# Access Compliance Report

## Public Rights-of-Way

### (Curb Ramps)

Intersection ID: 48956	Main Street: JOSHUA_CAIN_RD	Cross Street: DAVID_JENNINGS_AV	Location:	N
ADA ID: 5CE6B4AA938D	Ramp Type: Perp	Initial Pass/Fail: Fail	Overall Compliance: No	Severity Score: 8.75
Codes/Mitigation Info/Possible Solution		Field Measurements/Component Compliance

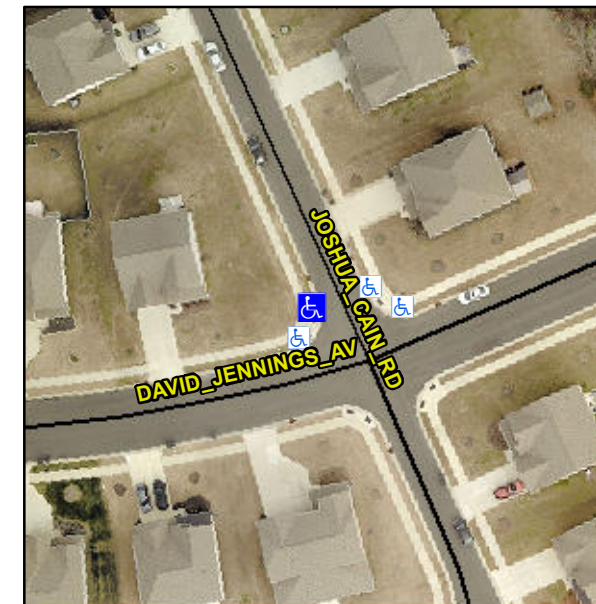
**Not Found, R304.5.1**

Compliance	Description	Data	Compliance	Description	Data
N/A	Ramp Length (in)	67.0	Yes	Ramp Slope (%)	6.8
No	Ramp Width (in)	47.5	Yes	Ramp XSlope (%)	1.5
N/A	Flare Type LT	N/A	N/A	Flare Type RT	N/A
N/A	Flare Slope LT (%)	N/A	N/A	Flare Slope RT (%)	N/A
N/A	Flare Traversable LT?	N/A	N/A	Flare Traversable RT?	N/A
N/A	Landing Length (in)	N/A	N/A	DWS Provided?	N/A
N/A	Landing Width (in)	N/A	N/A	DWS Contrast?	N/A
N/A	Landing Slope (%)	N/A	N/A	DWS Length (in)	N/A
N/A	Landing X Slope (%)	N/A	N/A	DWS Full Width?	N/A
N/A	Landing Curb? (Y/N)	N/A	N/A	DWS Offset (in)	N/A
N/A	Shared Landing?	N/A			
N/A	Gutter Ponding?	N/A	N/A	Gutter Slope (%)	N/A
N/A	Gutter Lip Ht (in)	1.0	N/A	Gutter X Slope (%)	N/A
N/A	Painted X Walk1?	No	N/A	Painted X Walk2?	N/A
	X Walk 1 Direction	To E		X Walk 2 Direction	N/A
N/A	X Walk 1 Width (in)	N/A	N/A	X Walk 2 Width (in)	N/A
	X Walk 1 Slope (%)	3.7		X Walk 2 Slope (%)	N/A
	X Walk 1 X Slope (%)	0.3		X Walk 2 X Slope (%)	N/A

**Remove & Replace Entire Ramp.**
